CMB Meeting Minutes #149

SUBJECT: Configuration Management Board Meeting # 149 – Rev. No. 0

Contract 1300 - PCC No. 6: STS AT&T Relocation

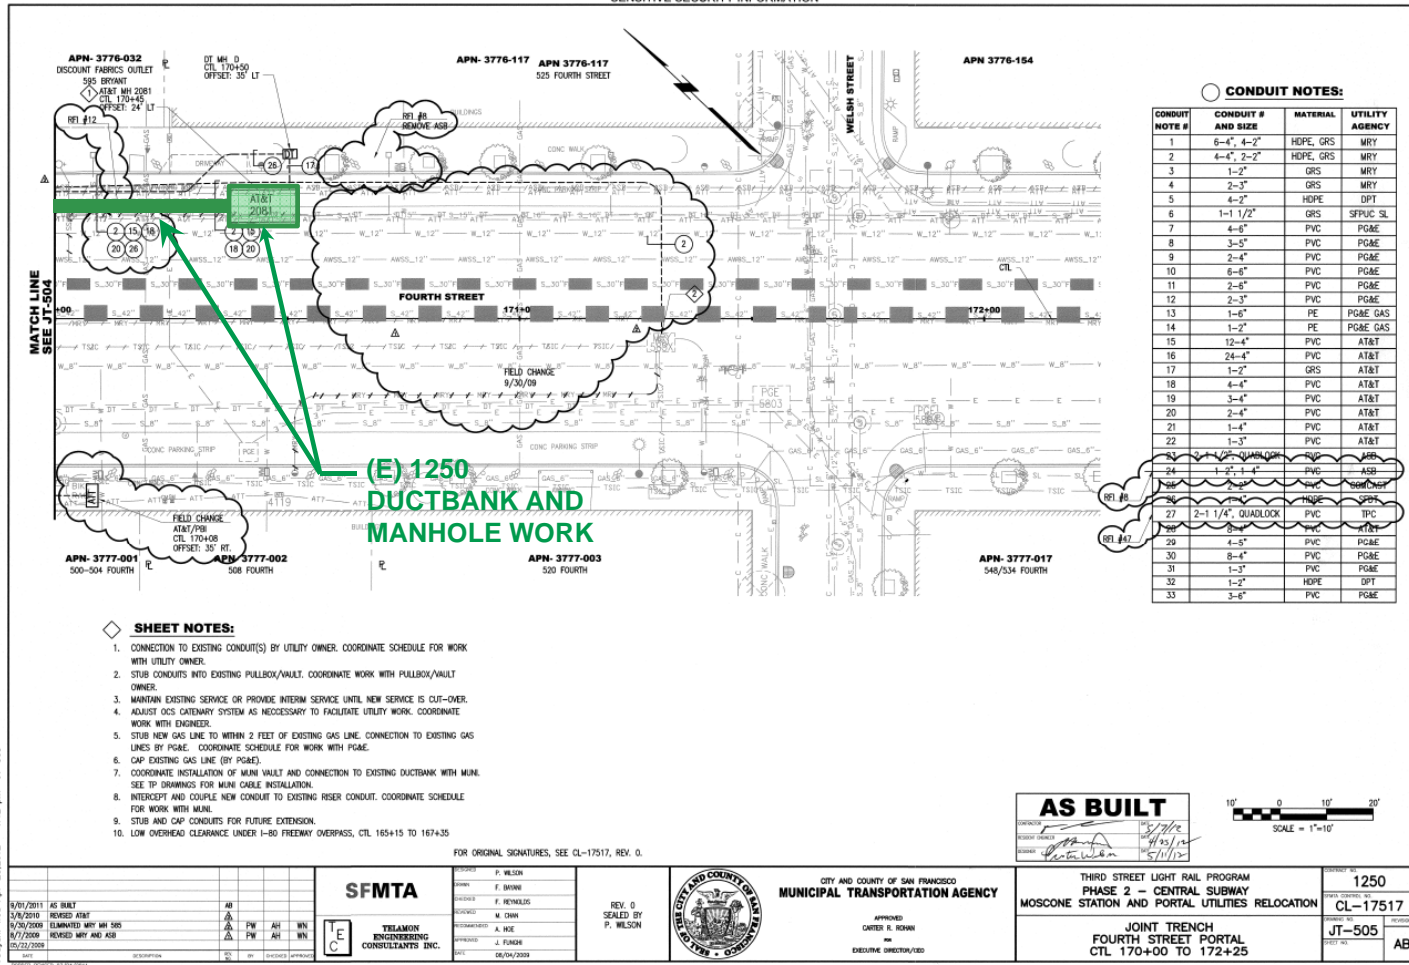
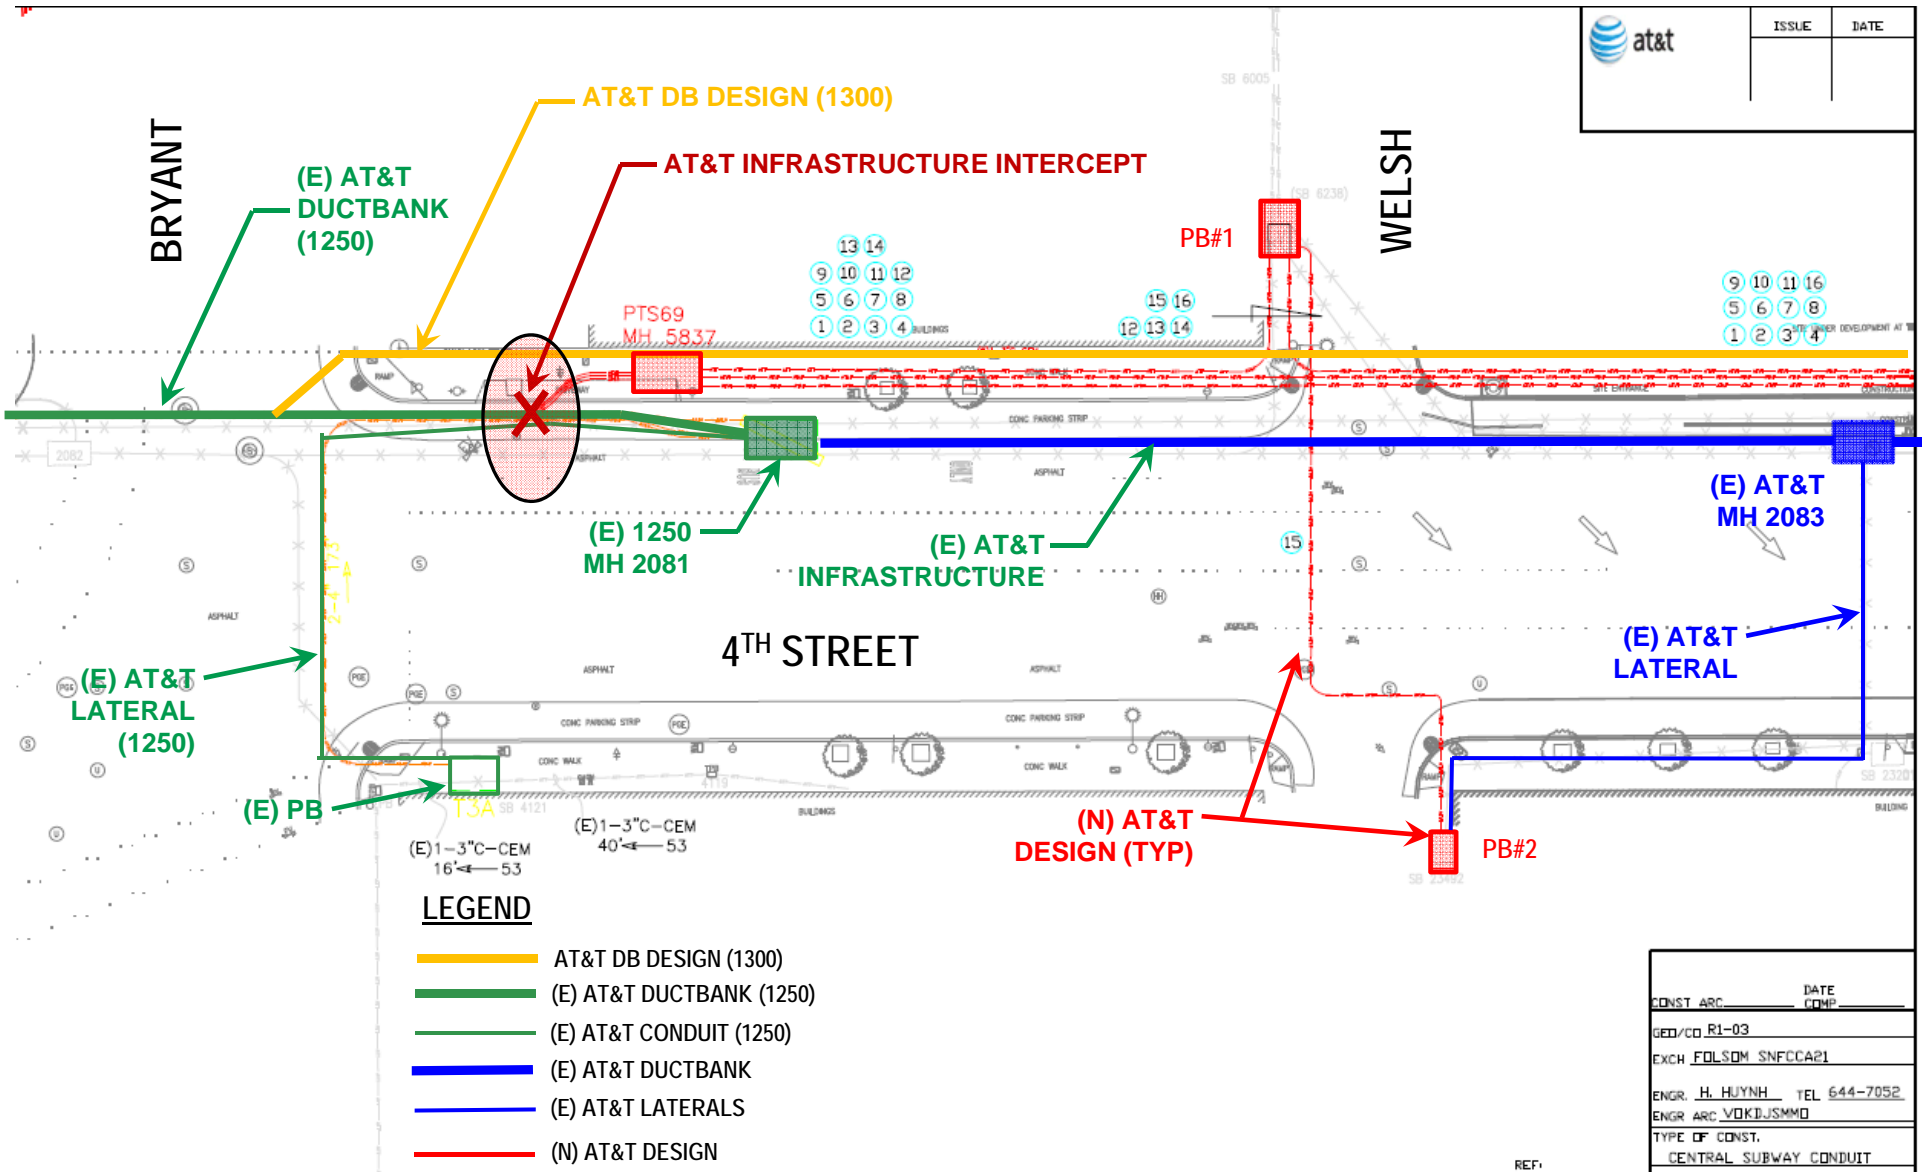
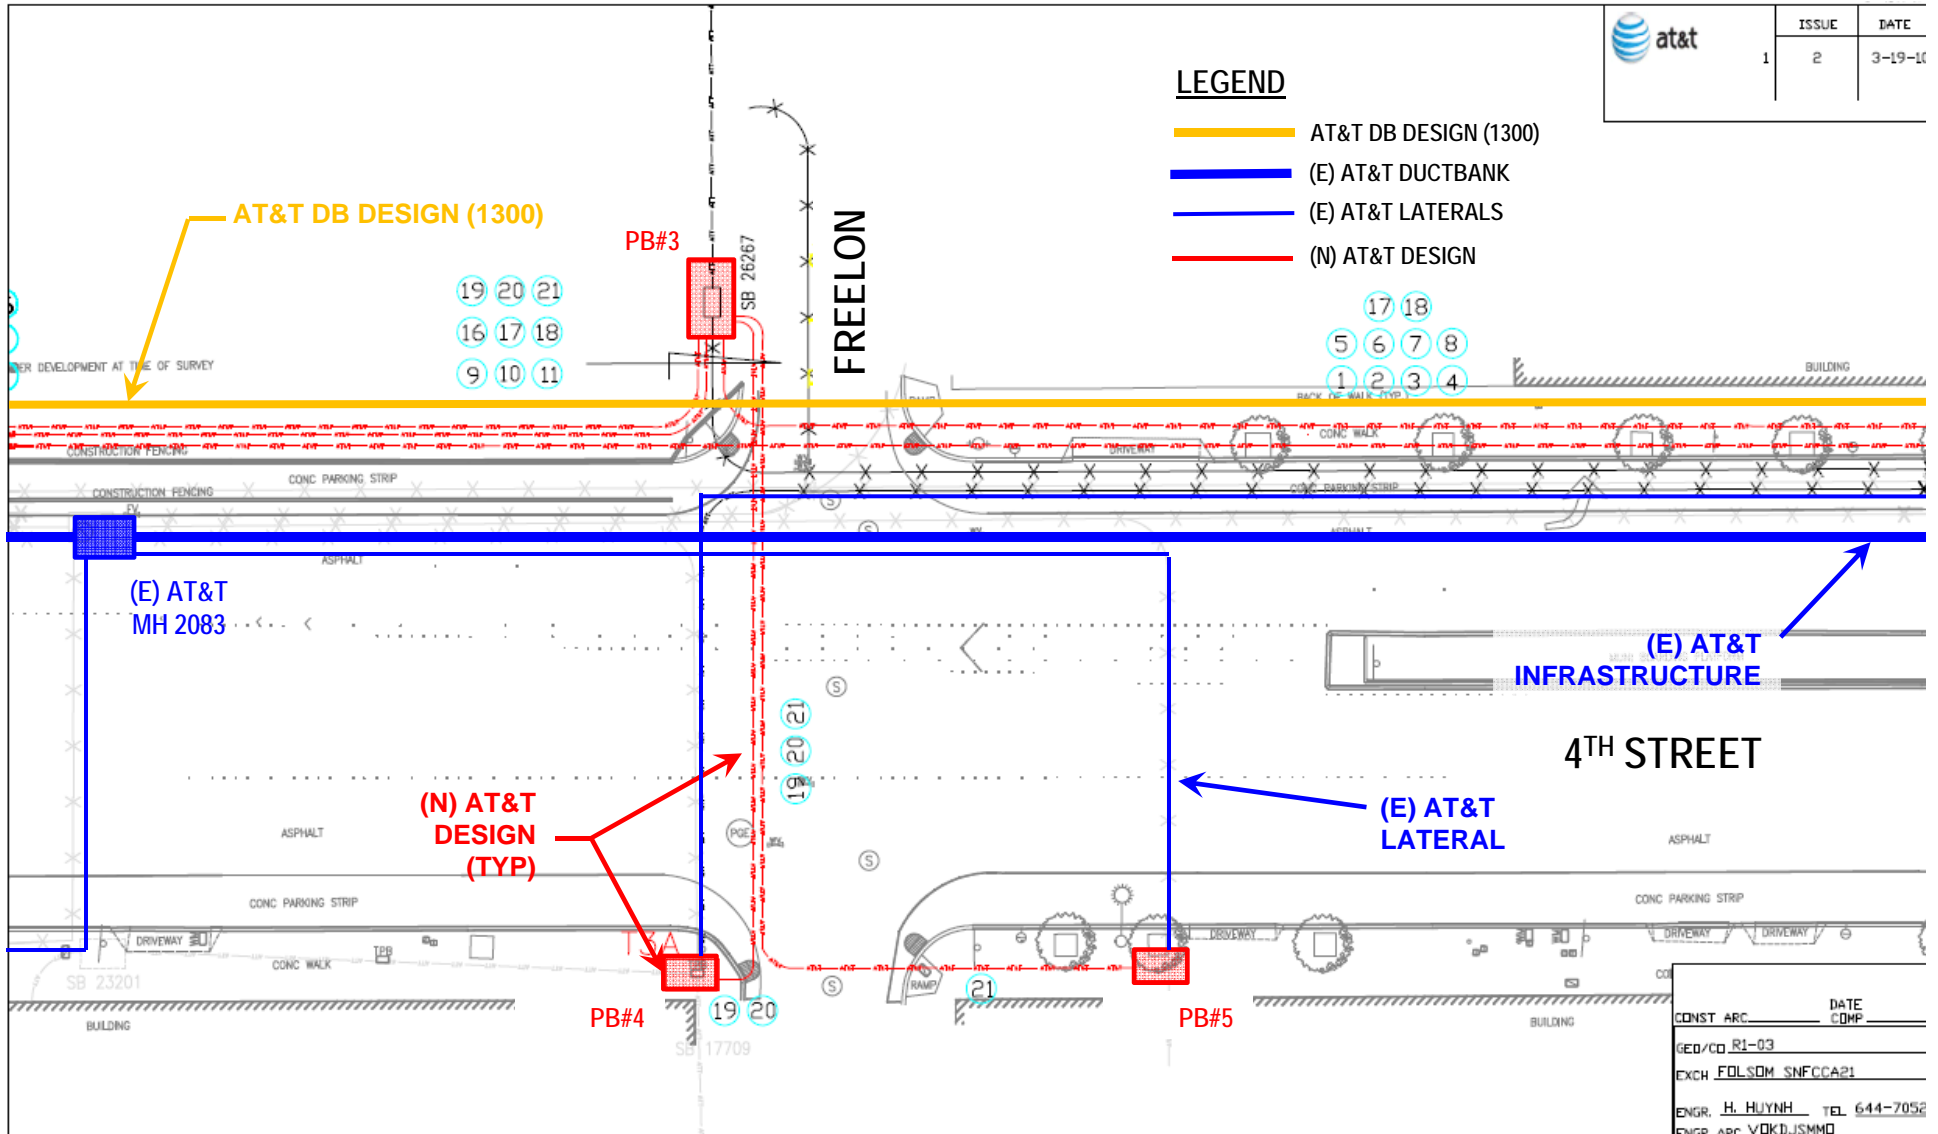
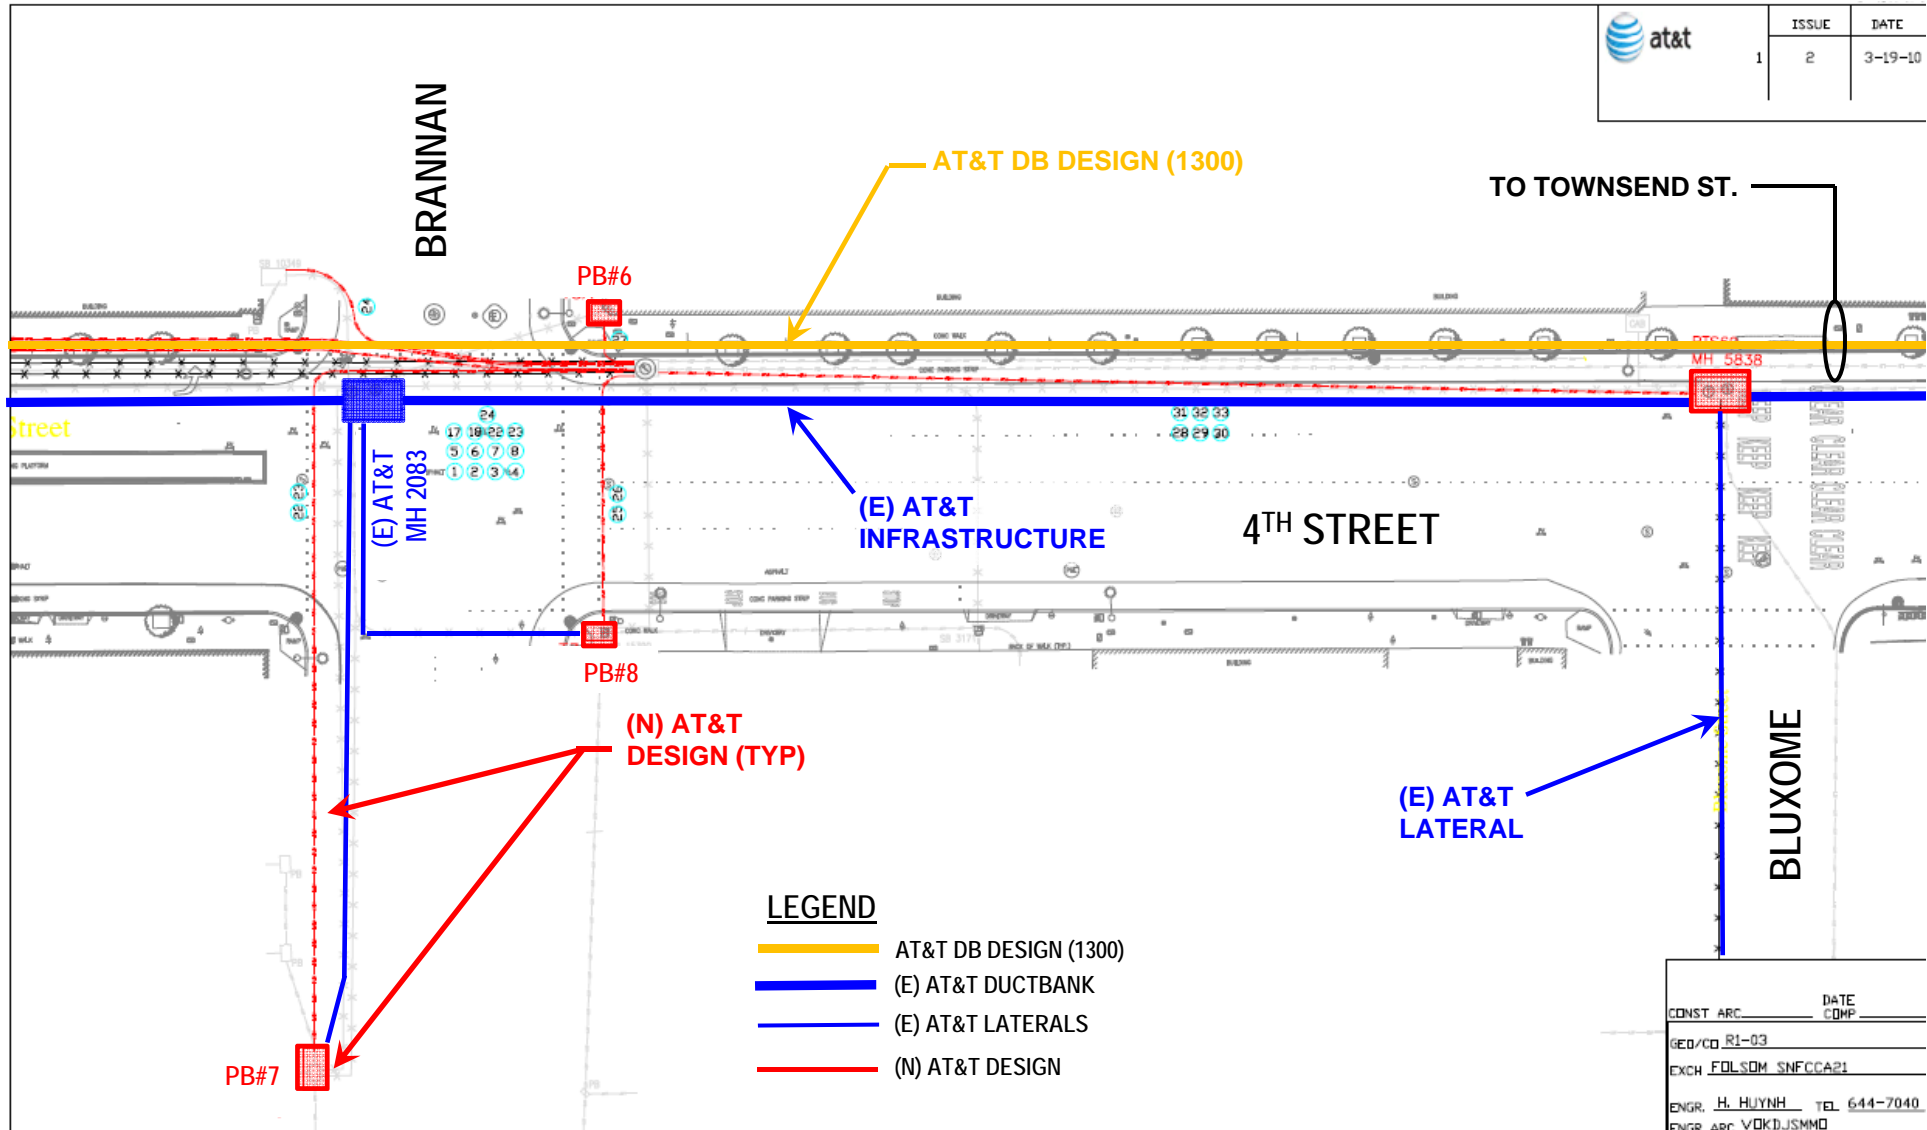
- Status of Relocation Work: Preliminary Design, Coordination and Potholing.
- Obtain authorization to proceed with additional potholing and coordination for PCC work.
- Obtain approval for merit and issuance of the PCC subject to verification of significant change, if any to the preliminary design after receipt of pothole information
- Estimated NTE cost for additional potholing and coordination is \$20,000
- Estimated total cost of PCC is \$176,345.87

<p>Description of PCC:</p> <ol style="list-style-type: none"> 1. Furnish and install additional AT&T manholes and pullboxes (2 each 14'x6'x9' manholes, 3 each 3'x5'x4' Type T5 Pullbox, 4 each 2.5'x4'x3' Type T3 Pullbox). 2. Provide additional excavation and restoration for one each manhole and 4 each T3 pullboxes. 3. Provide additional 568 linear feet of 2'x5' ductbank. Delete 394 linear feet 3'x6' ductbank and 720 linear feet of 4" conduits.
<p>Reason/Need for PCC:</p> <ol style="list-style-type: none"> 1. Contract Specifications 33 41 10, 2.04 and 3.05 specified that all manholes and pullboxes are to be furnished and installed by AT&T. However, AT&T requested that these manholes and pullboxes be installed by the Contract 1300 contractor pending AT&T approval of a fair and reasonable cost. 2. As a response to RFI 32.1, the new AT&T design called for installation of additional manhole and pullboxes as compared to the design concept depicted in contract plans UT-400 to 406, reference AT&T as-built drawing sheet no. 11A, and Contract 1250 as-built drawing. 3. As a response to RFI 32.1, the new AT&T design called for installation of additional 2'x5' ductbank and deletion of 3'x6' ductbank and conduits as compared to the design concept depicted in contract plans UT-400 to 406.

<p>Estimate: The estimated NTE cost for additional potholing and coordination is \$20,000. The total estimated cost of PCC is \$176,345.87, inclusive of potholing and coordination costs.</p>
<p>Spec. Ref.: Special Provision 37, Technical Specifications 33 41 10, Response to Bidder's Questions.</p>
<p>Drawing Nos.: UT-400 to UT-406, AT&T As-built Sheet 11A, Contract 1250 As-built JT-011 and JT-505</p>
<p>Attachments: Cost estimate, Special Provision 37, Technical Specifications 33 41 10, Response to Bidder's Questions, Plans UT-400 to 406, AT&T As-built Sheet 11A, Contract 1250 As-built JT-011 and JT-505</p>
